DESA Specialty Products™

Title 8-Button Remote			
Size C	Number 6005Zilog	Rev A	
Date Thu May 13, 2004	Drawn by Barry Atkins		
Filename 6005-8ButtonRevA.sch	Sheet 1	of 1

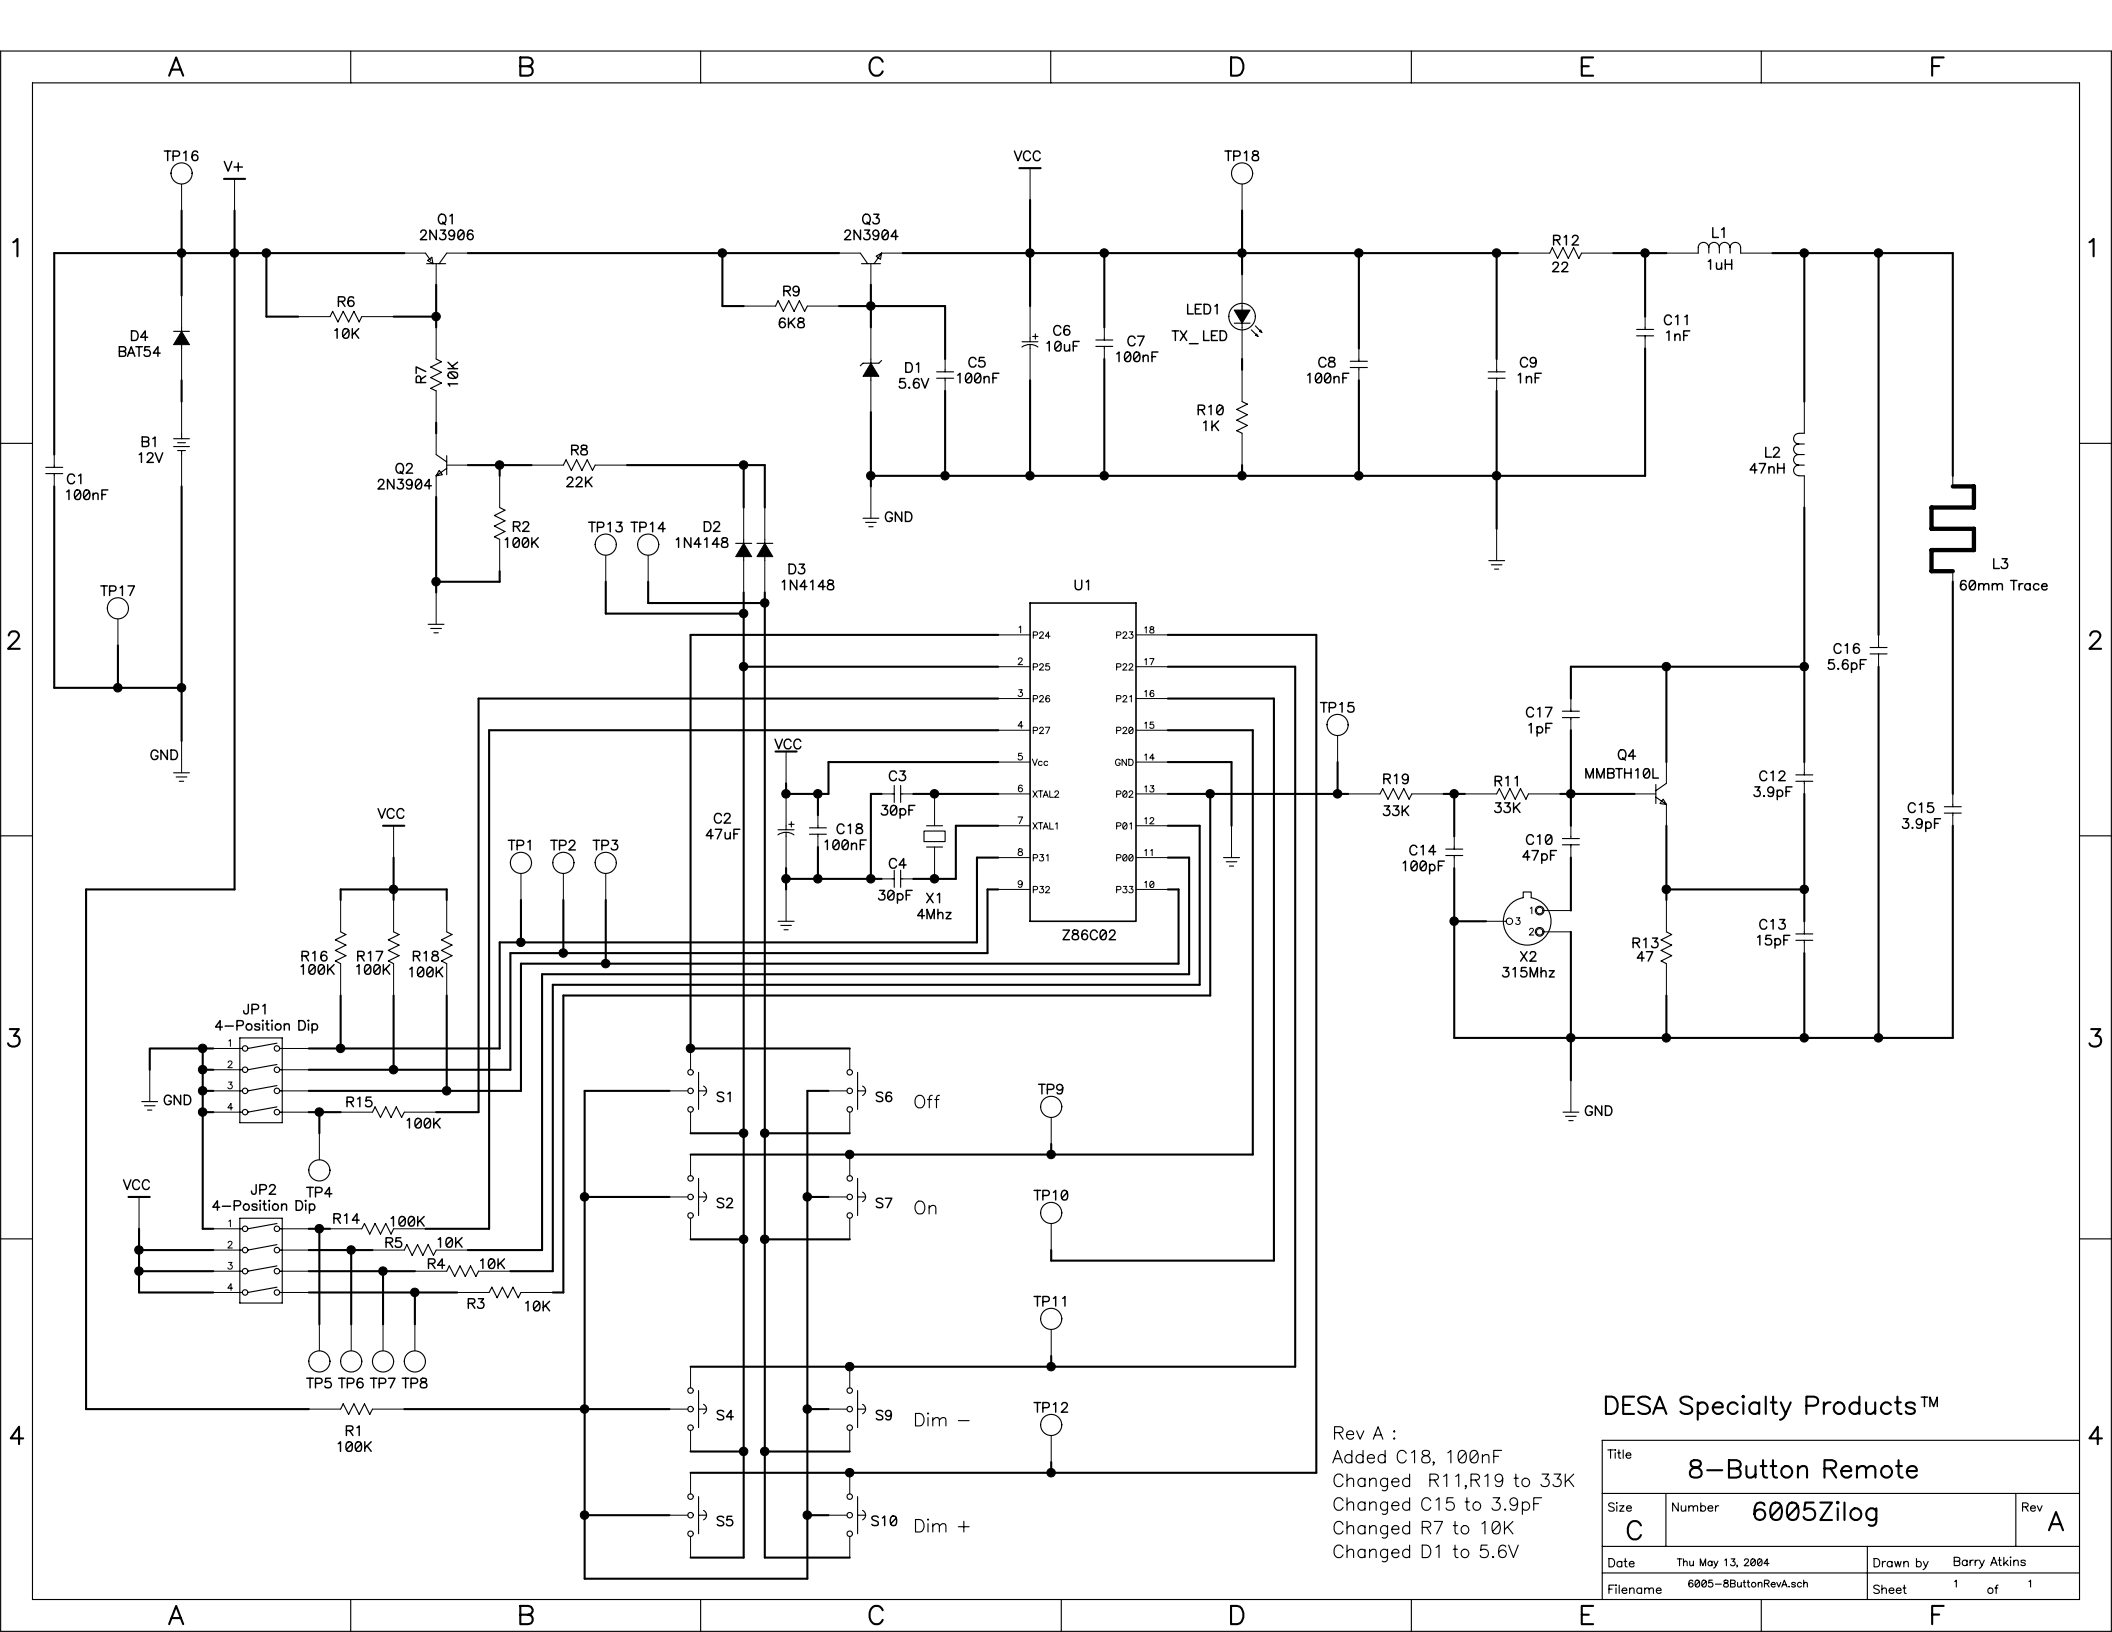
Rev A :
Added C18, 100nF
Changed R11,R19 to 33K
Changed C15 to 3.9pF
Changed R7 to 10K
Changed D1 to 5.6V
